**SUBJECT:** COMANCHE PEAK NUCLEAR POWER PLANT, UNITS 3 AND 4  
DOCKET NUMBERS 52-034 AND 52-035  
RESPONSE TO REQUEST FOR ADDITIONAL INFORMATION RELATED TO PART 1

**Response to Request for Additional Information Related to Part 1,  
Questions CP-01 through CP-06**

**Comanche Peak, Units 3 and 4**

**FIGURE 1.2-1  
Simplified Ownership Diagram**

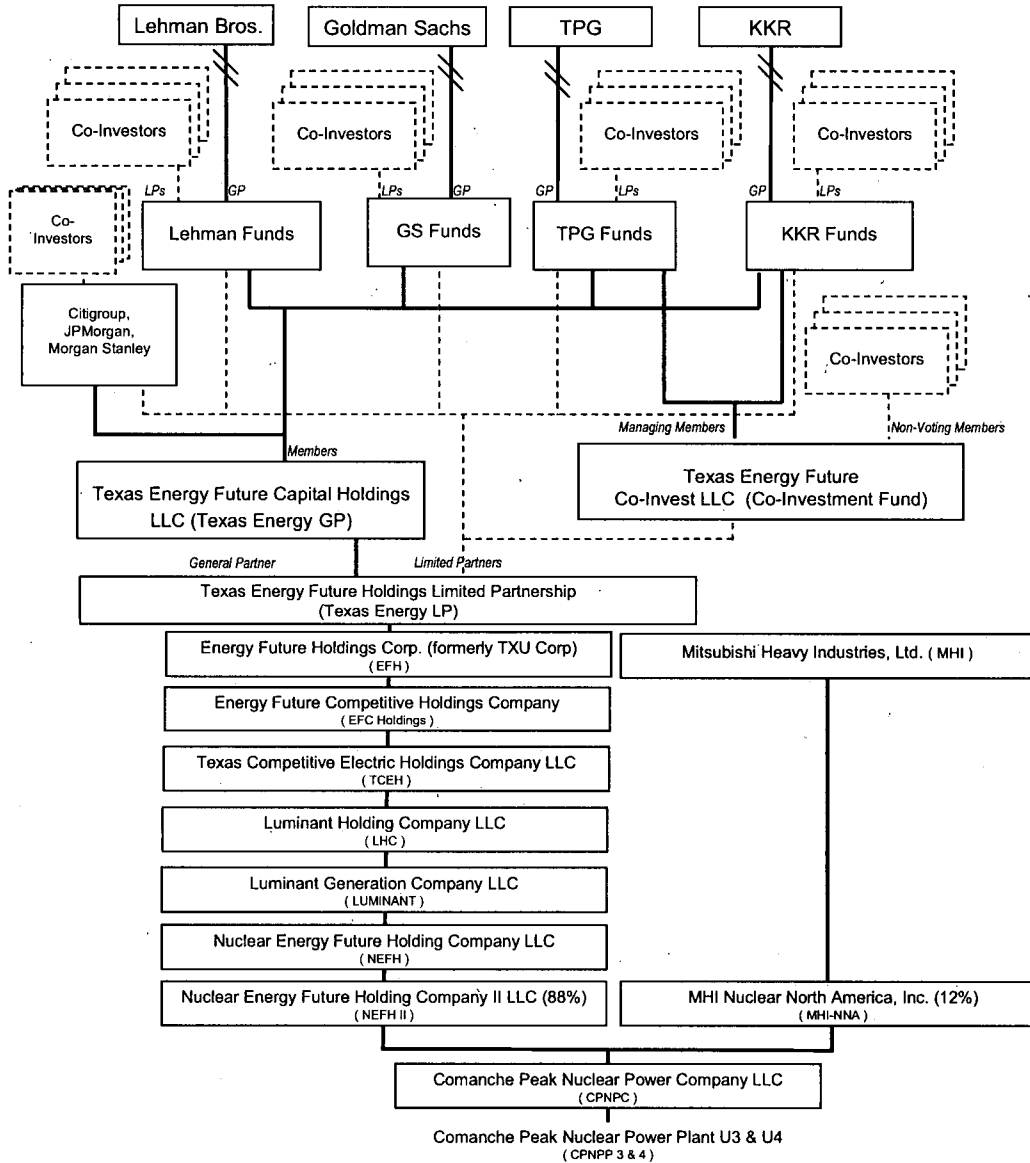
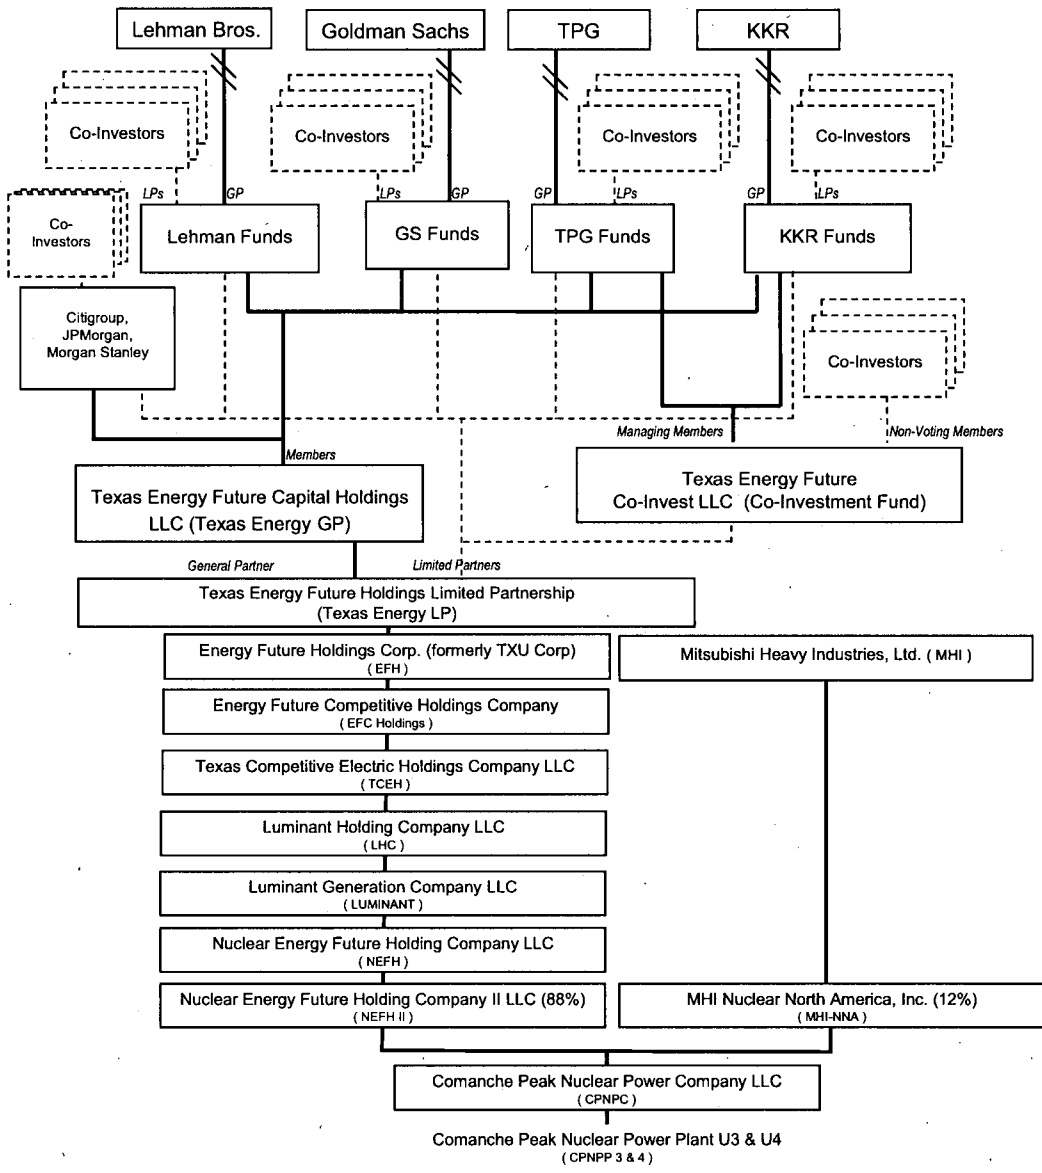
- a. Explain what relationship the joint venture, CPNPC, formed with MHI, will have with the overall corporate structure of Energy Future Holdings (EFH) and provide a diagram showing the relationships of MHI, the parent company, and subsidiaries within the EFH corporate structure.

Section 1.2.1 of COLA Part 1 has been revised to reflect that Luminant refers only to "Luminant Generation Company LLC". Rev. 1 of Part 1 clearly reflects the relationship between parent companies and their subsidiaries as displayed in revised Figures 1.2-1 and 1.2-2.

reflected in Figures 1.2-1 and 1.2-2. These diagrams are attached for convenience. (see also Response CP-04).
